ADDENDUM NO. 1
ENTIRE SHEET

DOWNTOWN CORRIDOR IMPROVEMENTS
CITY OF LAS VEGAS DEPT. OF PUBLIC WORKS
LAS VEGAS, NEVADA

STORM DRAIN
PLAN AND PROFILE
STA. 58+00 TO STA. 70+00

DWG. NO. 101-V-2286
FILE NO.
SHEET SD-3

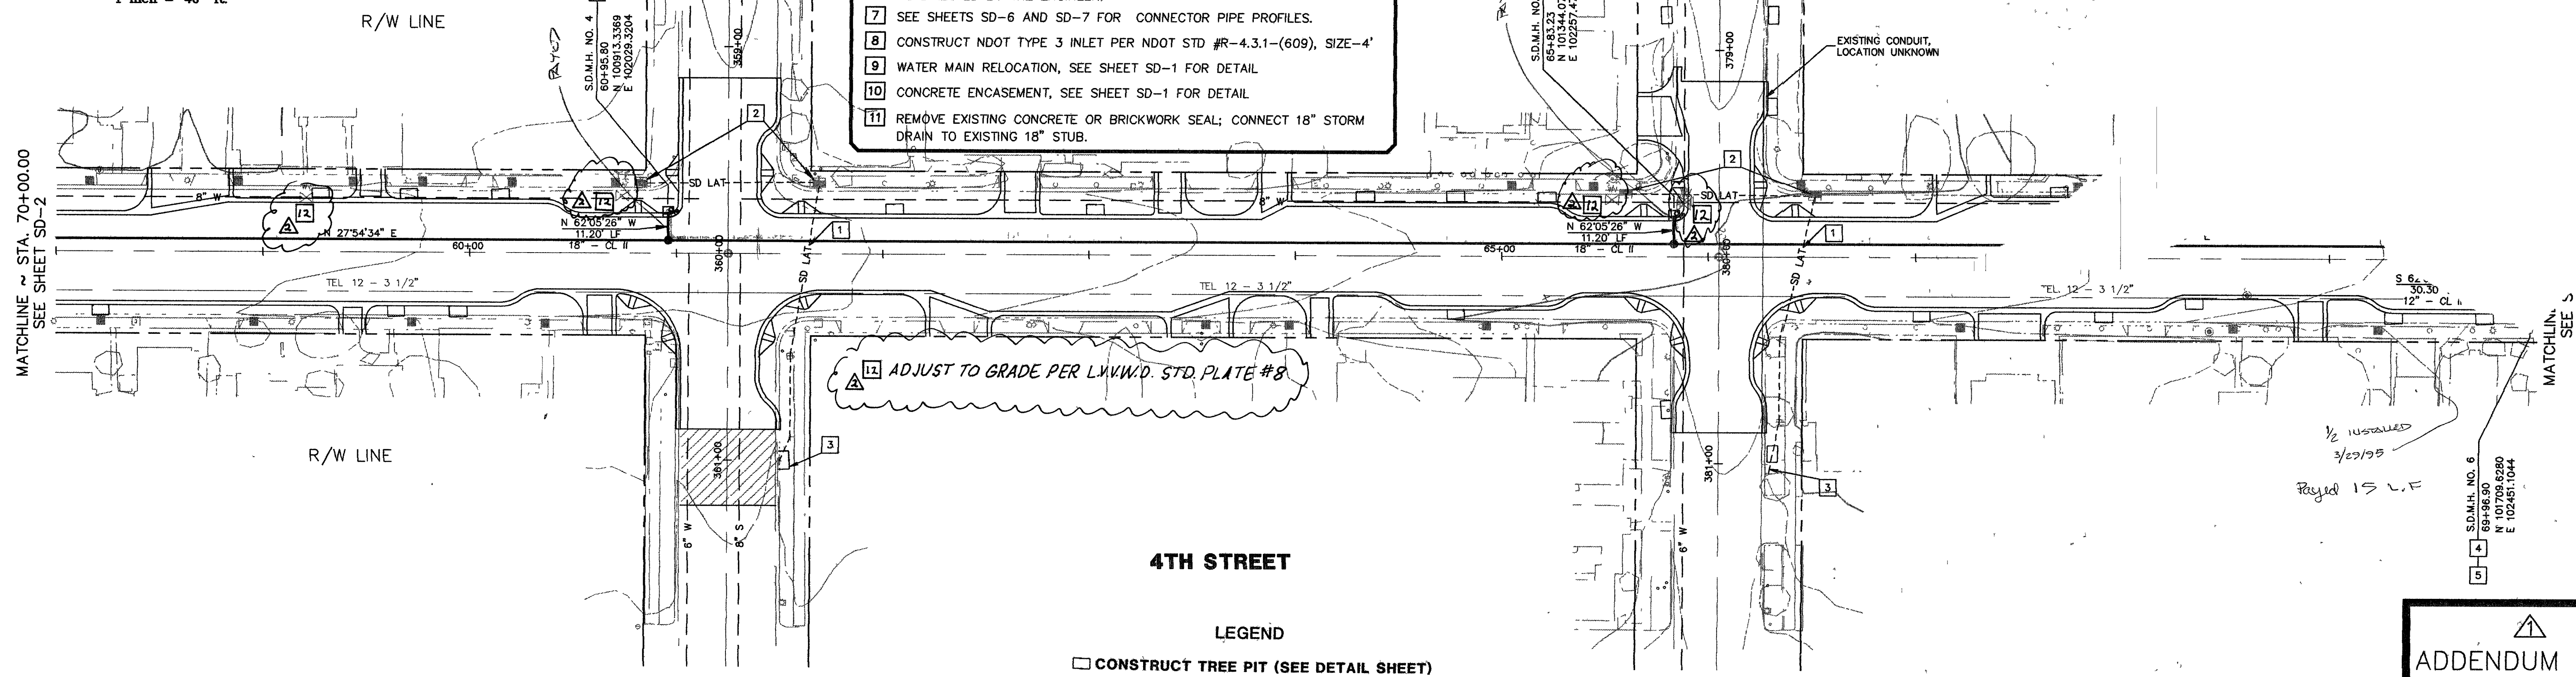
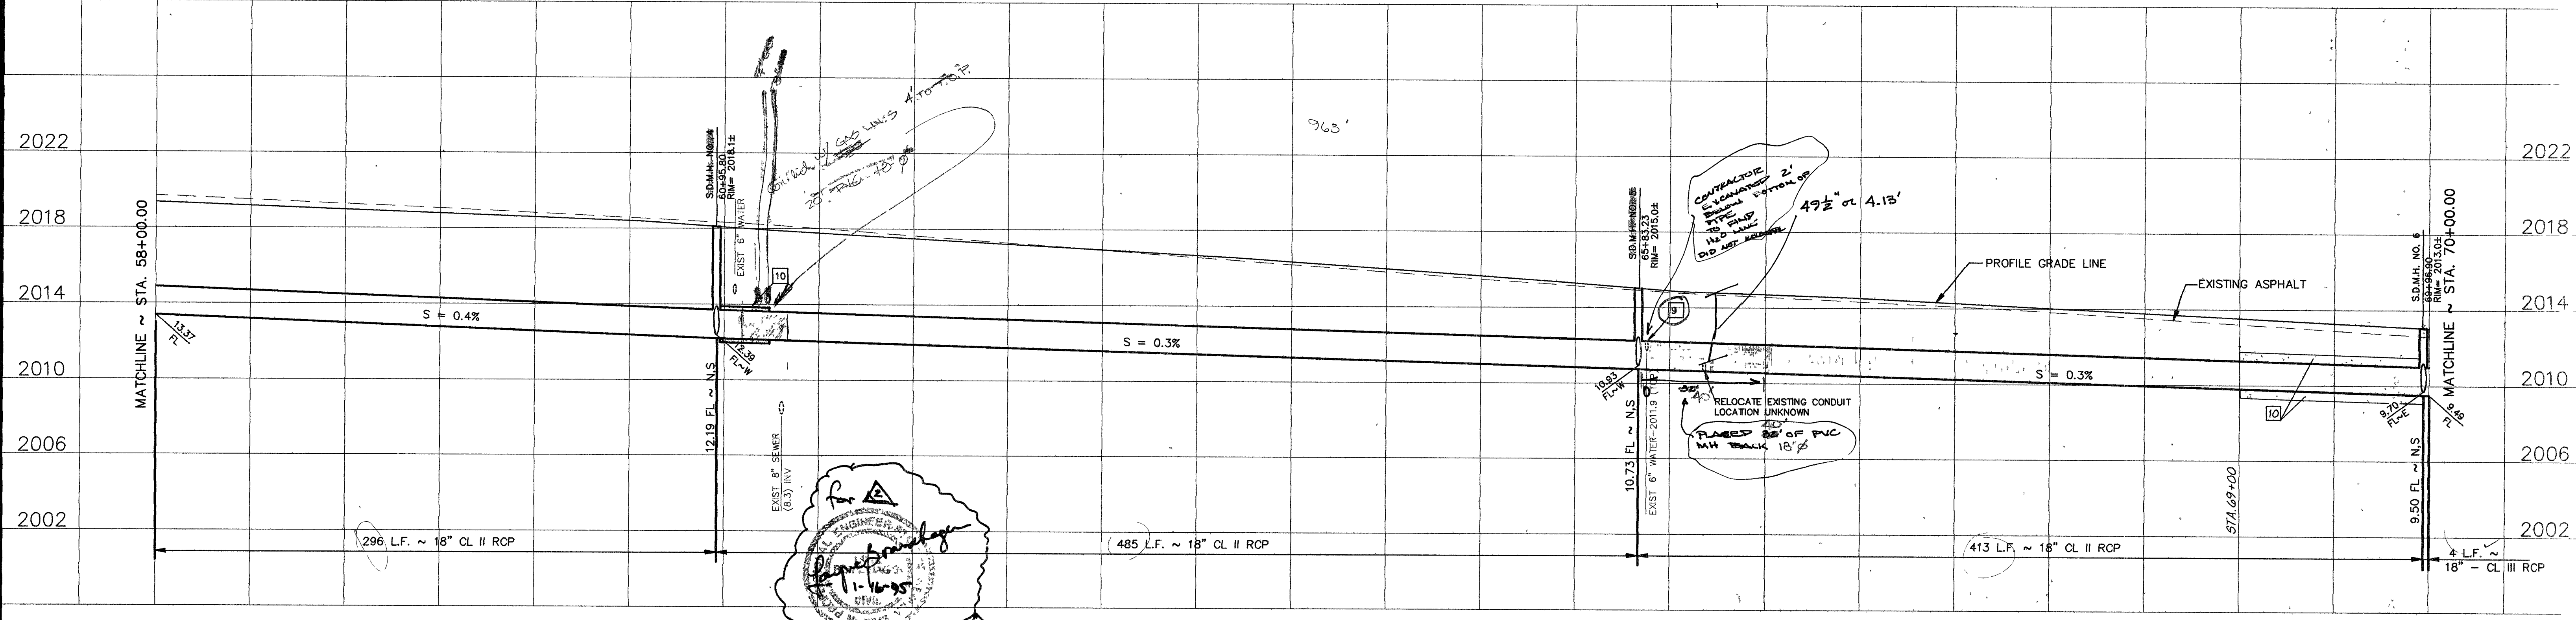
NO.	REVISIONS	DATE	BY
1	REVISION 1, ISSUED AS ADDENDUM NO.1, ENTIRE SHEET, MODIFYING NOTES, MODIFYING CLASS IV RCP IN PROFILE, ADDING CONCRETE ENCASEMENT, RIM ELEVATIONS WATER LINE RELOCATION, LVWD SIGNATURE BLOCK, 0.2' DROP IN CONNECTOR PIPE INVERTS.	12-10-94	DBB
2	PER LVWD REVIEW	1-13-95	DBB
